Issue	Description	TPUD Position	Doris Mast Position	David Mast Position	Don Aufdermauer Position
	Compliance with OAR 860-025-0030 Filing Requirements	OAR 860-025-0005 requires that an application for a CPCN "comply with all other applicable Commission rules."	TPUD has satisfied this condition.			
	OAR 860-025-0030(1)(b): Information required to be in the Application under OAR 860-025-0005					
1 0	Detailed line description	Tillamook PUD's Transmission Line will be operated at 115 kV and will be sourced from an existing breaker in BPA's Tillamook Substation. The Transmission Line will run 8.6 miles from the Tillamook Substation and terminate at the new Oceanside Substation.	The Application includes a detailed line description.	Only the transmission line and 2 new feeders are described in detail. The return of 22 MW to Tillamook on a rebuilt feeder 51 is not described. Without a rebuilt feeder 51 the 33 additional MW that the transmission project is promising cannot be delivered. A detailed description of how the worst feeder in the system, incapable of being rebuilt to provide 11 MWs to coastal communities can be rebuilt to provide 22 MWs to Tillamook is necessary and has been omit

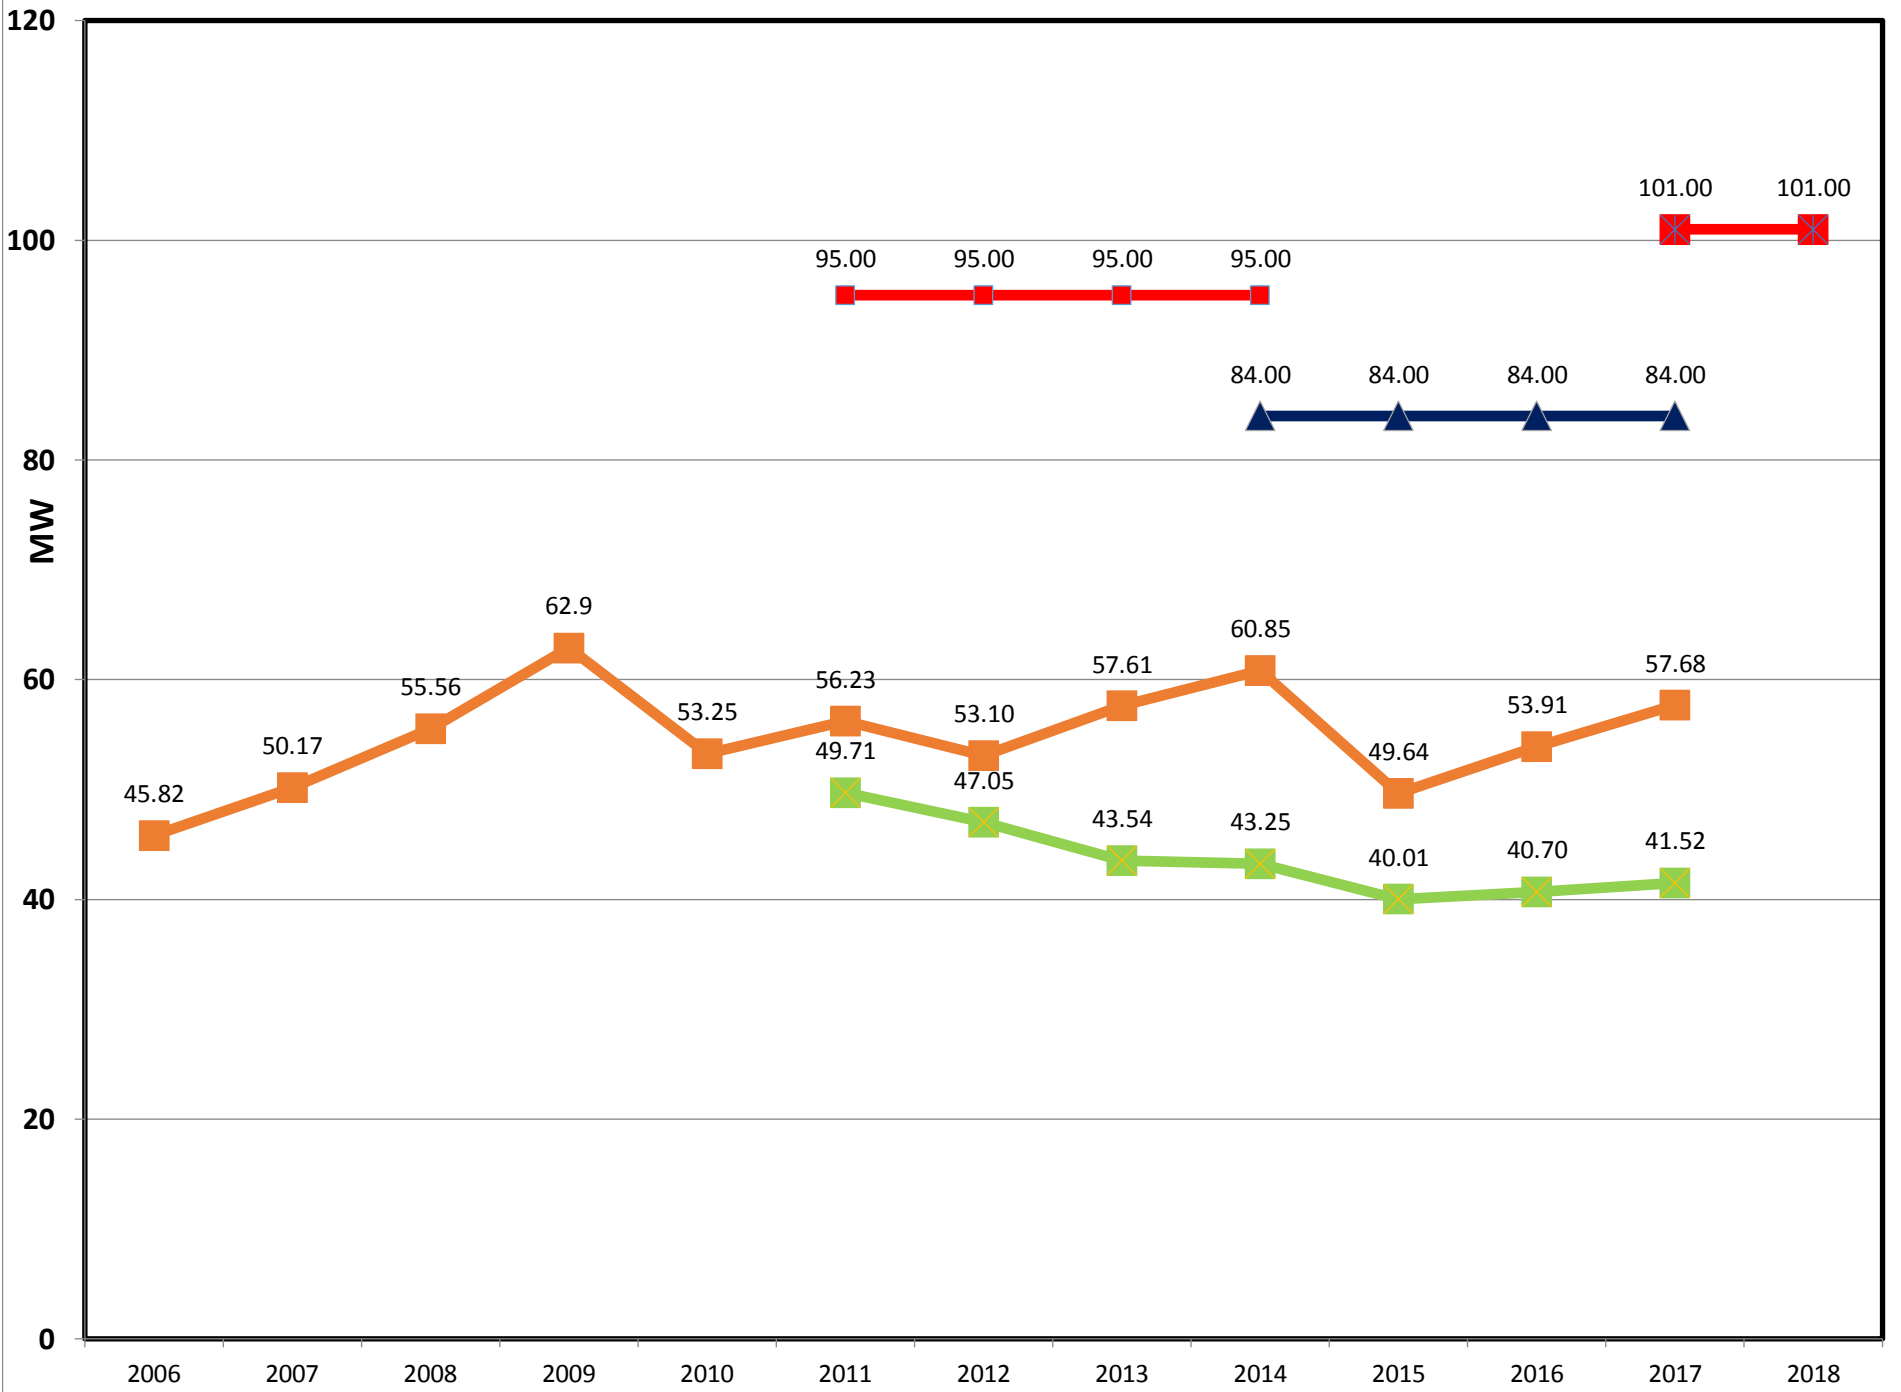
9	2	OAR 860-025-0030(1)(c): Spatial information	This rule provision requires an application for a CPCN to contain various maps and figures.	The Application includes the spatial information required by this rule.	There is no map showing the power returning to Tillamook on a rebuilt line 51. I am including a crude map of how TPUD plans to return 22 MWs of load from Oceanside to Tillamook on feeder 51 which has high outages from cars hitting poles and trees taking out the line.		
10	3	OAR 860-025-0030(1)(d): Cost information	This portion of the Commission's rules requires Tillamook PUD to provide estimated costs of certain components of the Transmission Line.	The Application includes the cost information required by this rule.	Option 3 costs less than half so all of the rate payers benefit.		They offered one time payment which was very low when the cities get monthly franchise fees and TPUD gets attachment fees from cable companies etc.

Wilson River I & II Loads & Peaks vs Thermal Rating (Capacity)

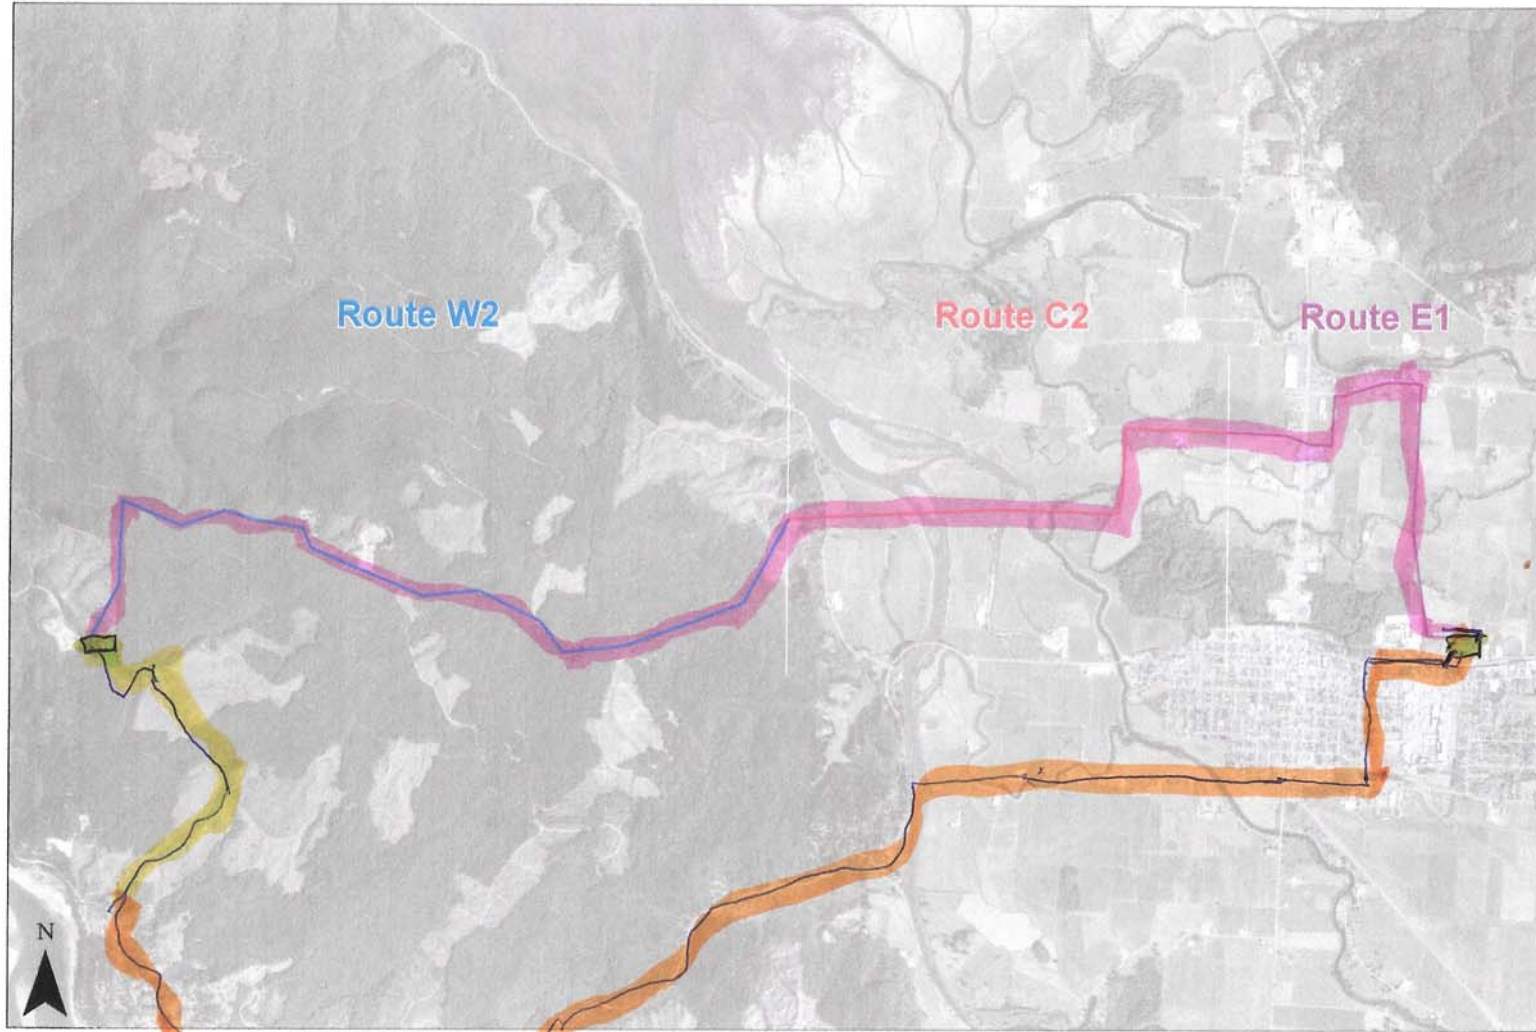
Issue	Description	TPUD Position	Doris Mast Position	David Mast Position	Don Aufdermauer Position	
14	7	OAR 860-025-0030(1)(h): Additional information	Tillamook PUD has conducted its own investigation into the need for the line and has determined it is in its customers' best interest to construct the line. The Transmission Line is needed to provide safe and reliable service to Tillamook PUD's customers.	TPUD has satisfied this condition.		TPUD eliminated Option 3 because of calculation errors even before it was presented to the public. Therefore Option 3 was never meant to be seriously considered. The transmission line option is the only option that TPUD has been advocating for the last 7 years. TPUD board ignored unsolicited public comments that returning power back to Tillamook on line 51 was not feasible.	TPUD has made errors in their math on Option 3. Routes have changed. They have not addressed the power coming back on line 51. How many other things are not reliable information?
